## D12A 14.12A Indicative roads and Trails

This report section is D12A of Part D Submissions Analysis of the section 42A report on the Infrastructure and Energy topic, Proposed Waikato District Plan. The report provides the consideration of submissions on indicative trails and indicative roads.

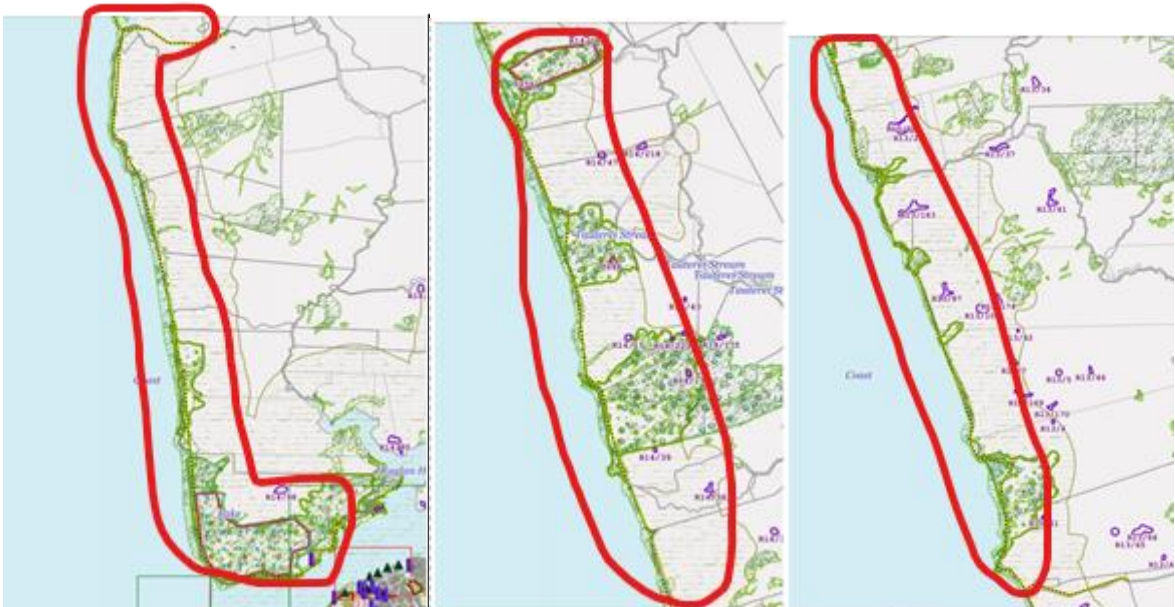
37. **Margaret Millard for The C. Alma Baker Trust** [704.1] seeks that the indicative trail is removed from their property at 1340 Port Waikato-Waikaretu Road, Port Waikato or deferred until the details of access, timing and cost are discussed with landowners.

38. This submission relates to the coastal track identified as 955 in the Trails Strategy as medium priority. As per the general approach discussed above, I accept the submitter's concerns that there is no mechanism or resourcing for acquiring the trails, and recommend this trail be removed to focus on high priority projects only within the PWDP at this stage.

40. Delete indicative trails 951, 952 and 955 along the northern coastline from Raglan and towards Port Waikato as roughly indicated in red circles on the figures below.

**Figure 1: PWDP map Track 4**

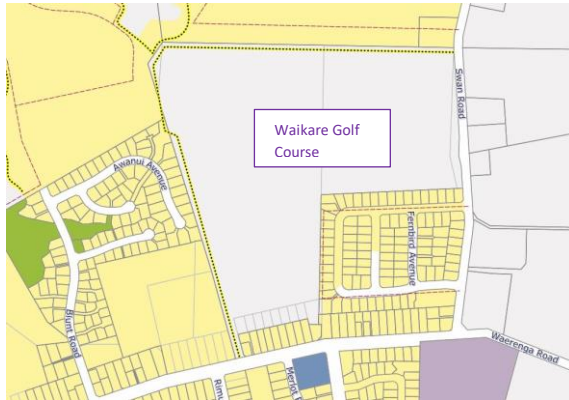
46. An indicative trail is identified along the western and northern boundaries of the Waikare golf course on the PWDP maps. The western extent reflects the Trails Strategy (Track 4) with the intention that it link up to Magnolia Close further to the west (see Figures 1 and 2 below).

47. It is unclear why the trail has been extended along the northern boundary of the golf course in the PWDP. The indicative trail adjacent to the golf course is identified as a high priority in the Trails Strategy. It is important to note that the alignment of the walkway is 'indicative' only, demonstrating the need to link two places together. The exact alignment would be determined at the time of subdivision or through acquisition by the Council. Accordingly, I consider it appropriate to retain the indicative trail along the western boundary of the golf course, but delete the indicative trail from the northern boundary, to be consistent with the Trails Strategy. I therefore recommend accepting the submissions in part.

**Figure 3: Notified trails vs Lakeside Precinct PI**

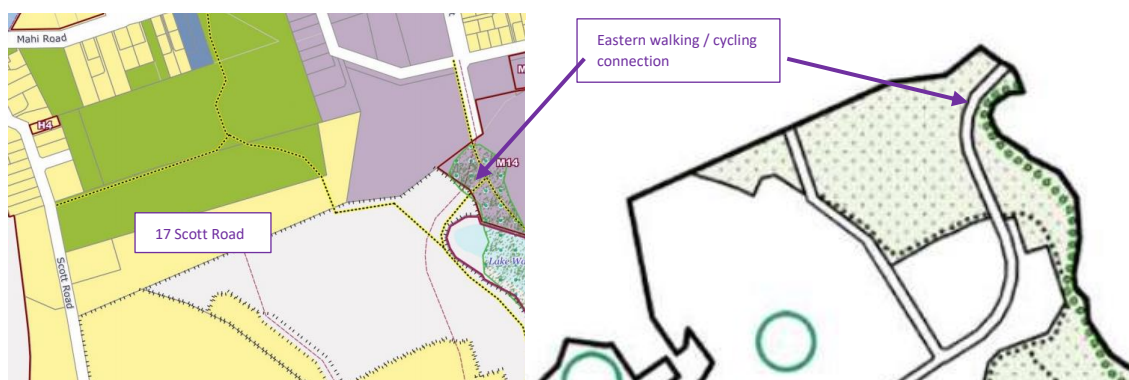
53. **Judy Garrick [374.1]** seeks deleting the cycleway through the property at 17 Scott Road, Te Kauwhata and amending the District Plan Maps to include a cycleway in the Lakeside development exit road. The submitter states that this is private land, and Health and Safety laws state that all persons using private land are the responsibility of the 'land owner' (if an incident or injury occurred as a result of work being conducted on or near the public land, then there would be liability under the Health and Safety at Work Act 2015). The submitter also states that the proposed cycleway through this land will cut off the end paddock and there will be no legal access for the submitter's stock, creating another health and safety issue when the submitter needs to move them. Furthermore, the drain running along this land poses a serious health and safety issue to anyone using this cycleway, and that creating a cycleway through the property will jeopardise any future development plans for this land (essentially splitting the title in two).

55. The trail at 17 Scott Road is not included in the Trails Strategy and does not connect to a walkway/cycleway shown on the Lakeside Precinct Plan. While the trail would have benefits in providing a connection between the lakeside and a future high priority trail around Te Kauwhata Domain open space, there is insufficient information supporting the location shown. The location of the trail could be considered in future, should the site be subdivided. The Council's focus for the PWDP is on implementing high priority trails. I note there is an alternative walking/cycling connection shown further to the east, from the Lakeside development to the town centre, which does match the Lakeside Precinct Plan (see Figure 3 below).

56. I recommend submission 374.1 be accepted in part, to the extent that the trail through 17 Scott Road be deleted but no amendment is made to include a cycleway in the Lakeside development exit road (the alternative route already seems to follow the exit road to Rata Street). I therefore recommend accepting *FS1371.5*, as a Rata Street cycleway exit would not be affected by the deletion of the portion of the trail.

**Map 14.2 excerpt [275.1; 193.1; 190.1; 191.1; 218.1; 239.1; 238.1; 236.1; 230.1; 199.1; 192.1]**

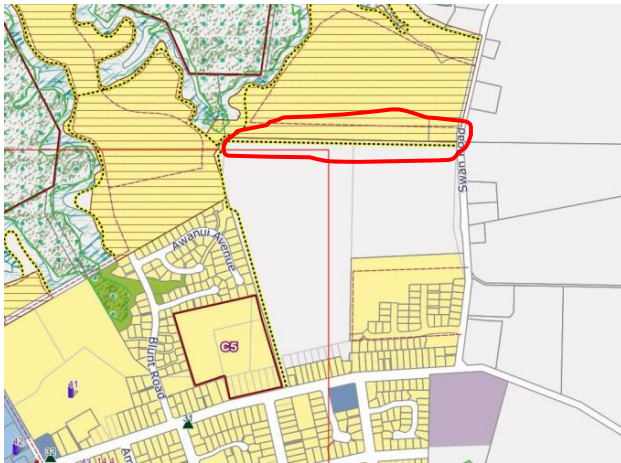
58. I recommend deleting the following indicative trails as outlined in red on the figures below:

- a. Along the northern boundary of the Waikare Golf Course
- b. At 24 Wayside Drive
- c. At 17 Scott Road

**Figure 4: Mangaharakeke Stream Trail 900**

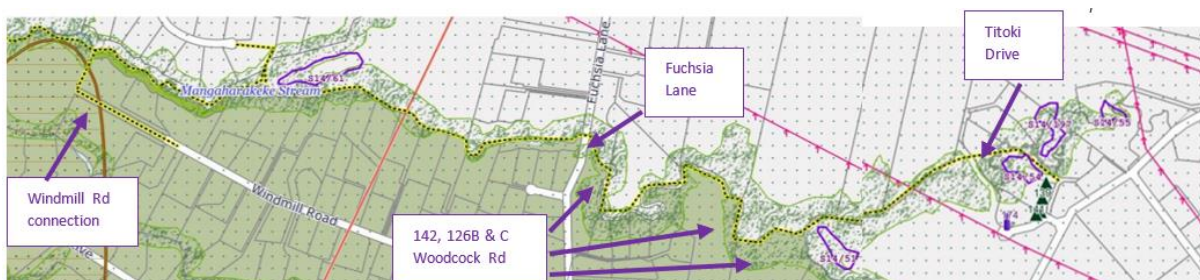
62. **Mark Emms** [75.3]; **Jon Harris** [327.2]; **Diane Emms** [282.3]; and **Colette Hanrahan** [77.2] seek to delete the walkway/cycleway/bridleway from Fuchsia Lane to Titoki Drive, Tamahere. **Mark Emms** [75.2] seeks to delete the walkway/cycleway/bridleway from the property at 126C Woodcock Road, Tamahere; **Roderick MacRae** [331.2] seeks to delete the Walkway Cycleway Bridleway overlay from the property at 142 Woodcock Road, Tamahere; **Colette Hanrahan** [77.1] seeks to delete the walkway/cycleway/bridleway from the property at 126B Woodcock Road, Tamahere; **Diane Emms** [282.2] seeks to delete the Walkway/cycleway/bridleway from 126c Woodcock Road, Tamahere. Figure 4 below shows the general locations referred to.

medium priority. Although the trail is considered to provide an important link it is anticipated that this could be achieved by an alternative method such as esplanade reserves at the time of subdivision. I therefore consider it appropriate to delete this indicative trail from the PWDP maps and recommend accepting the above submissions.

**Figure 5: PDWP map excerpt Windmill Rd**

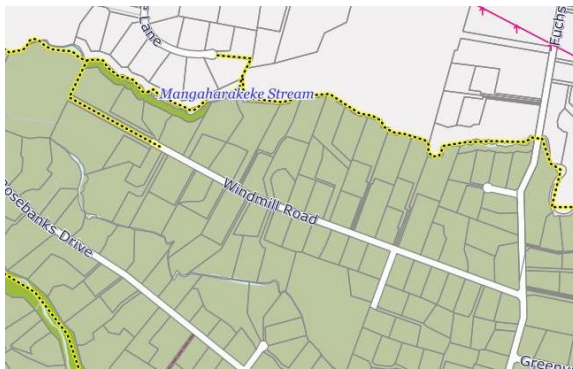
65. **Grace M Wilcock [845.7]** seeks to delete the walkway at the end of Windmill Road, Hamilton and across the private paddock and creek. The submitter states that this walkway serves no purpose as the terrain, once leaving the paddock, is extremely steep, and only experienced hikers would attempt to scale the sides of this gully. The submission explains that the creek area floods frequently and so the gully floor is then inaccessible, making this walkway even more impractical. The submitter considers the imposed Significant Natural Area further compromises the submitter's rights.

66. The indicative trail at the end of Windmill Road relates to the Tier I Existing on or off-road/facility along Windmill Road identified in the Tamahere Cycle Strategy 2016 (Figure 6). However, in the strategy the cycleway does not extend beyond the end of the road to link up to the Mangaharakeke Stream as identified in the PWDP maps. It is unclear on what basis the indicative trail was identified and I therefore do not consider it appropriate to retain it. I recommend accepting submission 845.7.

**Figure 8: 33 Kowhai Street – excerpt of Map 7.1**

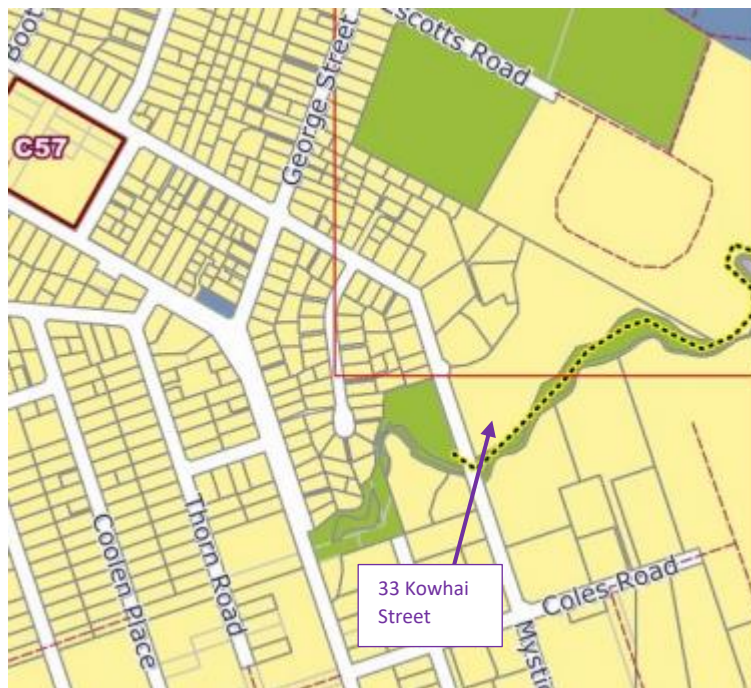
81. **Chanel Hargrave and Travis Miller** [751.40] seek to amend the location of the Walkway, Cycleway, Bridleway from the property at 33 Kowhai Street, Tuakau to be contained within the reserve to the southeast of the site.

82. The indicative trail at 33 Kowhai Street relates to Track 300 identified in the Trails Strategy as a high priority project (see Figure 8 below). The PWDP identifies the trail as indicative and the exact location is to be determined at the time of subdivision. I note that there is an existing reserve alongside the stream and that the indicative trail appears to be intended to align with the edge of this. I do not consider it necessary to amend the location of the indicative trail because it is indicative only, and therefore recommend rejecting Chanel Hargrave and Travis Miller [751.40].

**Figure 9: Tuakau Trail proposed by submission Bruce Titchmarsh [34.1] (attached to submission)**

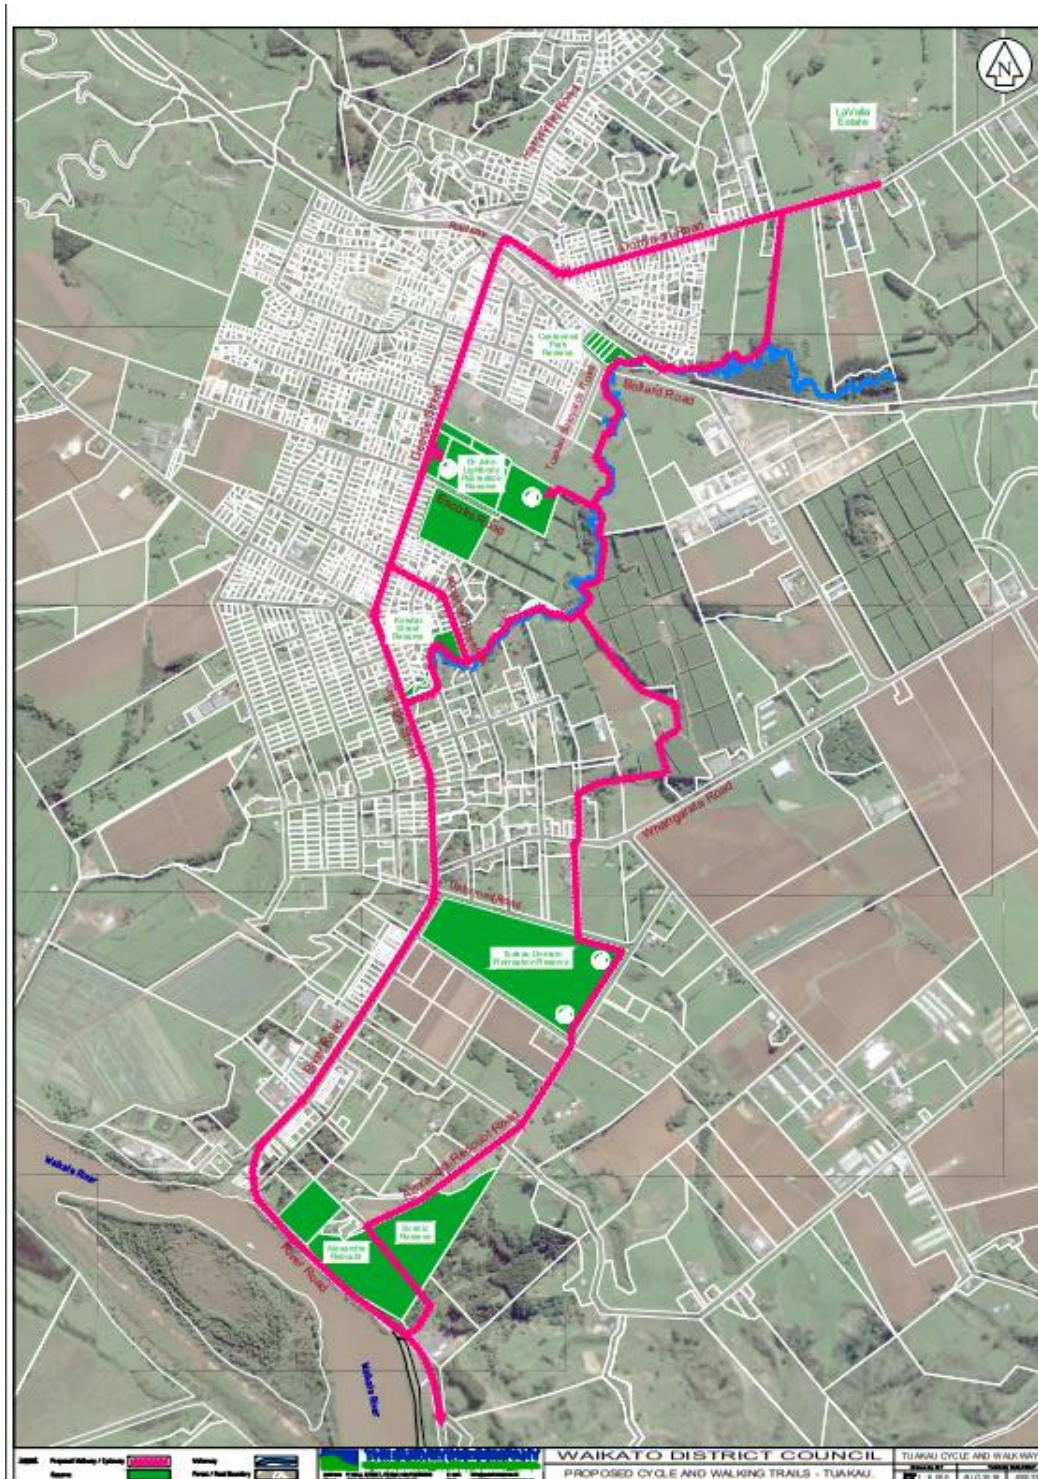
83. **Brett Titchmarsh** [34.1] seeks the planning maps be amended to include a walkway/cycleway for Tuakau as shown on the map attached to the submission (see Figure 9). Submission 34.1 seeks a series of additional walkway/cycleways, some of which align with the Trails Strategy. Other than Track 300, which is already included in the PWDP, those identified by the submitter are medium and low priority projects as well as some additional linkages between these trails. I do not support additional indicative trails because they were not included in the notified PWDP or the Trails Strategy and therefore have not had adequate consultation. The appropriate process for identifying new or additional trails is through the next iteration of the Trails Strategy and an implementing plan change. I therefore recommend rejecting Brett Titchmarsh [34.1].

**Figure 7: PWDP map Redwood Grove**

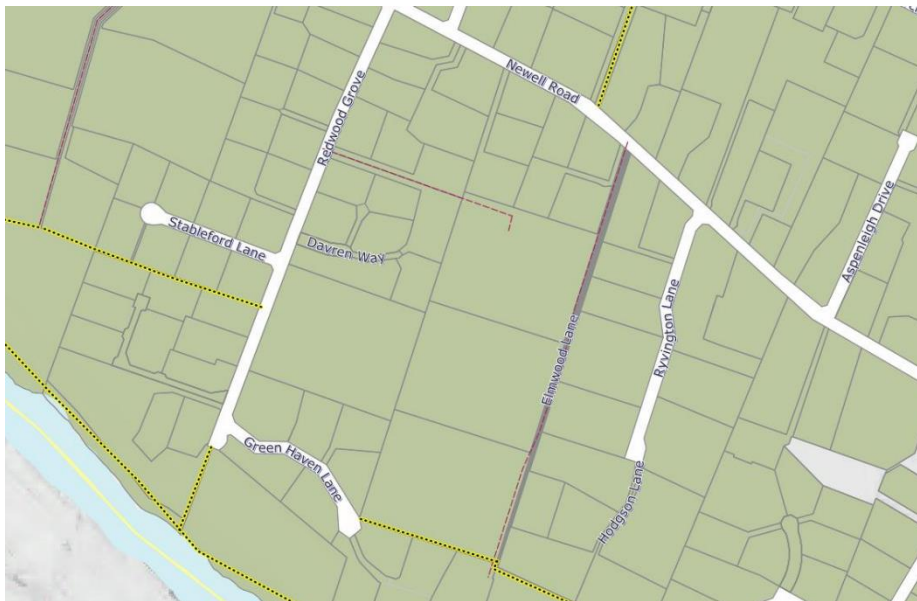
126. **Brendhan Greaney on behalf of Multi-Party Submission** [694.1] seeks to delete the indicative road off Redwood Grove, Tamahere, from the Proposed District Plan. The submitter group is comprised of the owners of 14 properties on Redwood Grove and the owners of 256 Newell Road. The reasons given include that the intention of the Redwood Grove indicative road was to provide access to the block of land on 264 Newell Road. The submitters explain that this property has subsequently subdivided with access provided to each of its lots off Newell Road, making the original purpose of the Redwood Grove indicative road redundant.

127. The submitter identifies that the properties bordering the Redwood Grove indicative road were purchased with the knowledge of the indicative road, as it is drawn on the current Operative Plan; the submitters explain that the properties were purchased and further developed on the basis that the indicative road would be removed from the District Plan at the next review (commencing 2017) for at least the following reasons:

131. The scope provided by the PWDP and the submissions is only to retain or delete all or part of the indicative road off Redwood Grove. Resolution of the need for the indicative road from Redwood Grove into future subdivisions appears to depend on all or part of Elmwood Lane becoming public road, or some other alternative form of access. I could support the removal of the indicative road off Redwood Grove (as shown on Figure 7 above), if the matter can be resolved by Council accepting vesting of Elmwood Lane as public road, with all properties enabled access. Advice from Council roading engineers is that Elmwood Road is not yet designed to public road standards. Therefore, access to this road for the future properties in the area is not yet secured. I note that there appears to be substantial additional subdivision potential down Elmwood Lane, all the way through to the river. The owners of properties accessed via Elmwood Lane own individual rights-of-way easements to access their properties, and those easements would need to be acquired or surrendered to create a public road. If Elmwood Lane is upgraded and vested/acquired as public road in future, I would expect the indicative road will not need to be provided through future subdivision processes. If the road and future access can be determined then the indicative roads can be removed from the planning maps. The Panel may wish to provide a direction to the Council that a solution to the road access must be confirmed by a specified date (say 21 June 2021) before the release of the decision on the PWDP, to allow an alternative decision to the indicative roads remaining on the planning maps. Unless the road access can be agreed before the PWDP decision is made, I recommend rejecting Brendhan Greaney on behalf of Multi-Party Submission 694.1; *FS1151.1 Sue Robertson on behalf of Tamahere Community Committee, accepting FS1013.1 Chantelle Berry; FS1011.1 Mong Oon Yeow.*
